SEWAGE DISPOSAL SYSTEM  
HOWARD COUNTY HEALTH DEPARTMENT  
BUREAU OF ENVIRONMENTAL HEALTH  
410-313-2640

P 514238

A REPAIR

SUBDIVISION        LOT NUMBER        ADDRESS 12118 Frederick Road

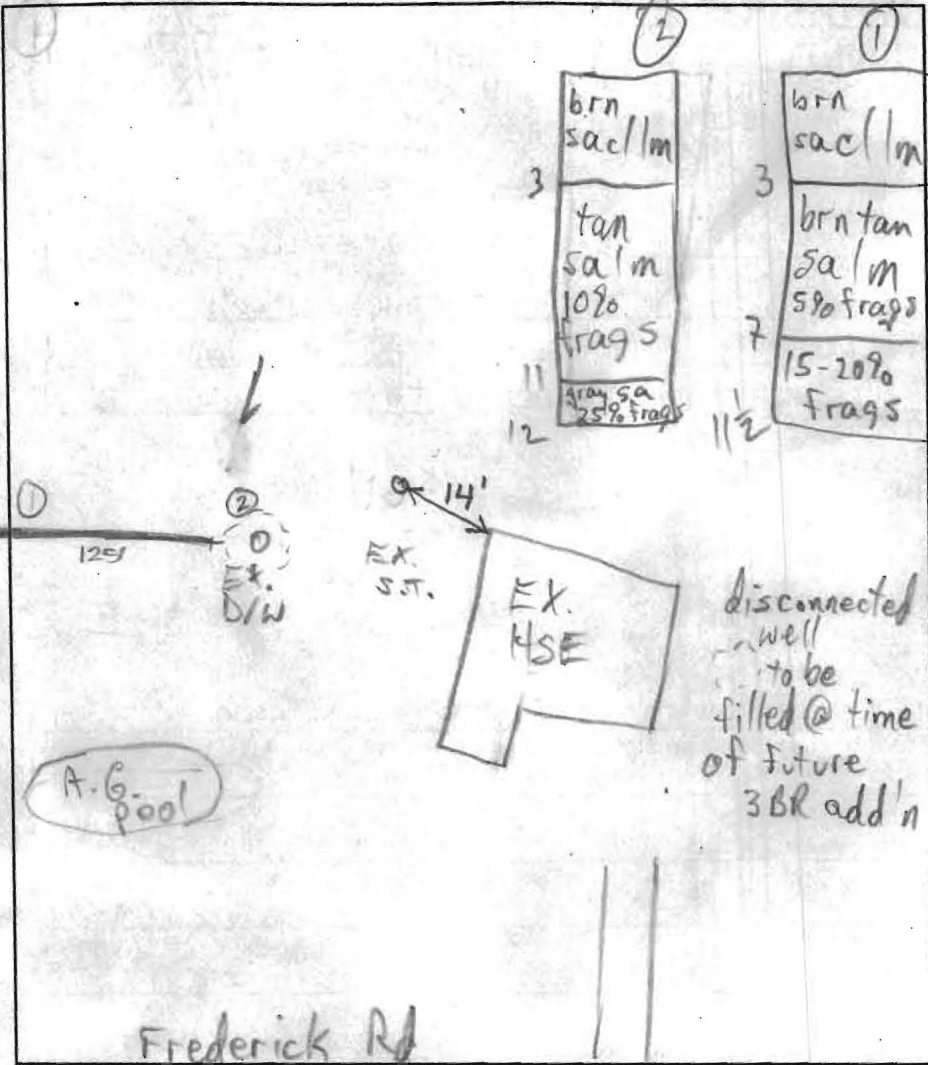
INSPECTION COMMENTS: 9/8/00 4:20± SYSTEM COVERED; JENKINS REPORTS #0E MAN (RONNIE) WAS TO LEAVE SYSTEM OPEN; I ADVISED JENKINS SYSTEM NOT APPROVED UNTIL FURTHER NOTICE & STS. EXCAVATED; HE AGREED (MR)

9/18/00 contractor opened ends of trench - reports installing above specified trench. OK to cover. DLC
